Access Compliance Report

Public Rights-of-Way

Intersection ID: 13061	Main Street: LARCH_ST	Cross Street: MERRIMAN_AV	Location: S
ADA ID: 4346B4A8FB5A	Ramp Type: PerpDiag	Initial Pass/Fail: Fail	Overall Compliance: No
			Severity Score: 33.75

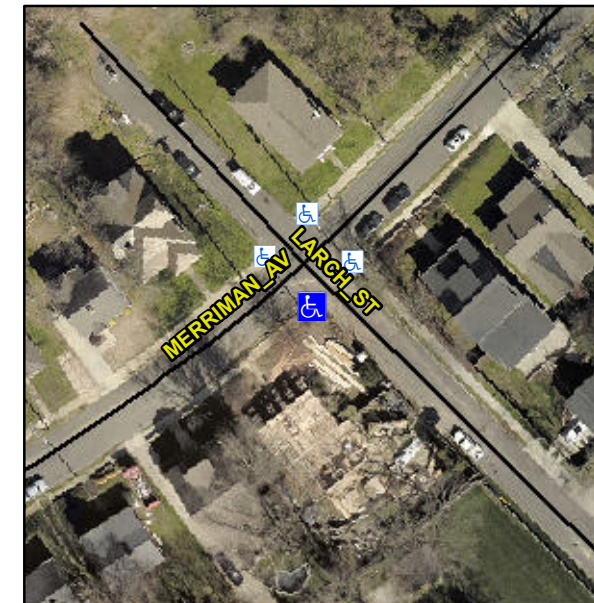
Not Found, R304.5.1, R304.2.2, R304.5.3

Compliance	Description	Data	Compliance	Description	Data
N/A	Ramp Length (in)	62.0	No	Ramp Slope (%)	9.7
No	Ramp Width (in)	45.0	No	Ramp XSlope (%)	5.2
N/A	Flare Type LT	N/A	N/A	Flare Type RT	N/A
N/A	Flare Slope LT (%)	N/A	N/A	Flare Slope RT (%)	N/A
N/A	Flare Traversable LT?	N/A	N/A	Flare Traversable RT?	N/A
N/A	Landing Length (in)	N/A	N/A	DWS Provided?	N/A
N/A	Landing Width (in)	N/A	N/A	DWS Contrast?	N/A
N/A	Landing Slope (%)	N/A	N/A	DWS Length (in)	N/A
N/A	Landing X Slope (%)	N/A	N/A	DWS Full Width?	N/A
N/A	Landing Curb? (Y/N)	N/A	N/A	DWS Offset (in)	N/A
N/A	Shared Landing?	N/A			
N/A	Gutter Ponding?	N/A	N/A	Gutter Slope (%)	N/A
N/A	Gutter Lip Ht (in)	N/A	N/A	Gutter X Slope (%)	N/A
N/A	Painted X Walk1?	No	N/A	Painted X Walk2?	No
	X Walk 1 Direction	To NE		X Walk 2 Direction	To NW
N/A	X Walk 1 Width (in)	N/A	N/A	X Walk 2 Width (in)	N/A
	X Walk 1 Slope (%)	3.0		X Walk 2 Slope (%)	3.3
	X Walk 1 X Slope (%)	3.2		X Walk 2 X Slope (%)	2.4

Remove & Replace Curb Ramp With Two New Directional Ramps or Equivalent.
